Item ID: D212-664-101TRN

Item Name: Crosstube Turning Detail

DART AEROSPACE LTD		Work Order:	116469
Description: Crosstube Assembly (205/212/412 High Fwd)		Part Number:	D212-664-141
Inspection Dwg: D212-664-141 Rev: D		Page 1 of 2

DRAWING NO. D212-664-141	TITLE XTUBE ASSY (205/212/412 HI FWD)	REV. D	DART AEROSPACE LTD ENGINEERING ORDER		D.E.O. NO. D212-664-141-D-1	SHEET NO. SHEET 1 OF 2	SCALE NTS
DRAWN	CHECKED	<i>OP</i>	MFG. APPR.	<i>RE</i>	APPROVED	<i>WAP</i>	DE APPR.
DATE 11.04.07	DATE 11.04.11		DATE 11.04.12		DATE 11/04/12		DATE 11.04.12

D212-664-141/-141B
ASSEMBLY DETAIL

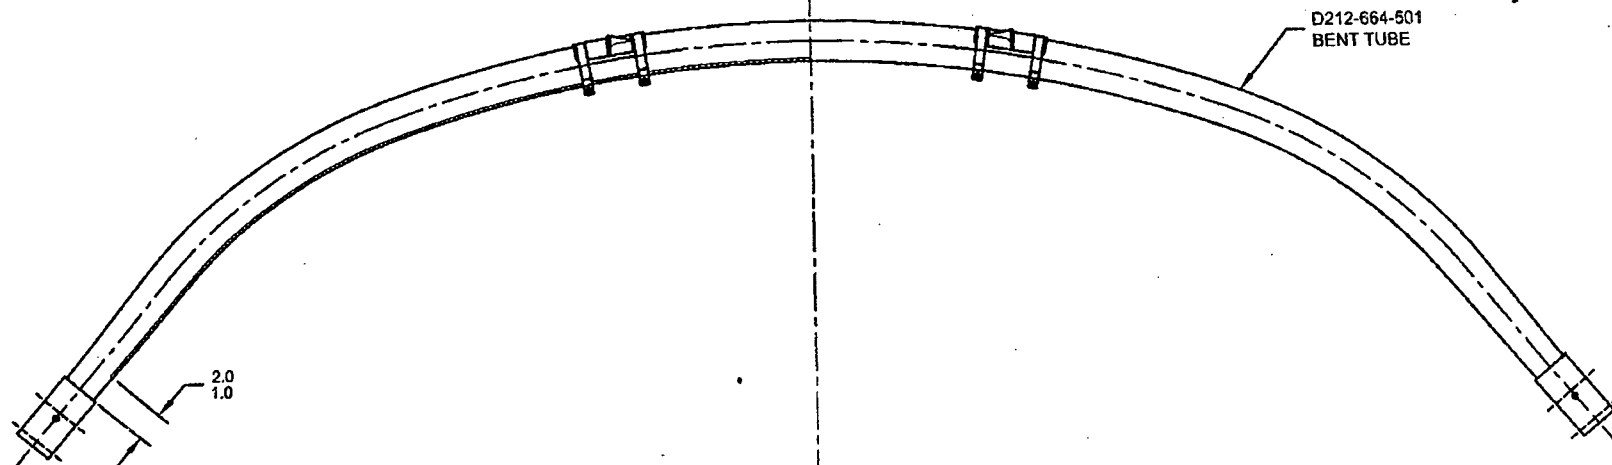
PURPOSE:

ADD AN INSPECTION WINDOW TO UNDERSIDE OF CROSSTUBE.

NOTES 2 OF SHEET 1 IS AMENDED AS FOLLOWS:

IS:

- 2) FINISH: CHEMICAL CONVERSION COAT PER DART QSI 005 4.1
PRIME INSIDE AND OUTSIDE PER DART QSI 005 4.2
MASK UNDERSIDE OF CROSSTUBE AS SHOWN (HATCHED AREA) AND
PAINT OUTSIDE PER DART QSI 005 4.2
REMOVE MASKING AND APPLY CLEAR COAT

WAS:

- 2) FINISH: CHEMICAL CONVERSION COAT PER DART QSI 005 4.1
PRIME INSIDE AND OUTSIDE PER DART QSI 005 4.2
PAINT OUTSIDE PER DART QSI 005 4.2

MASK AREA PRIOR TO PAINTING,
REMOVE MASKING AFTER PAINT
AND APPLY CLEAR COAT
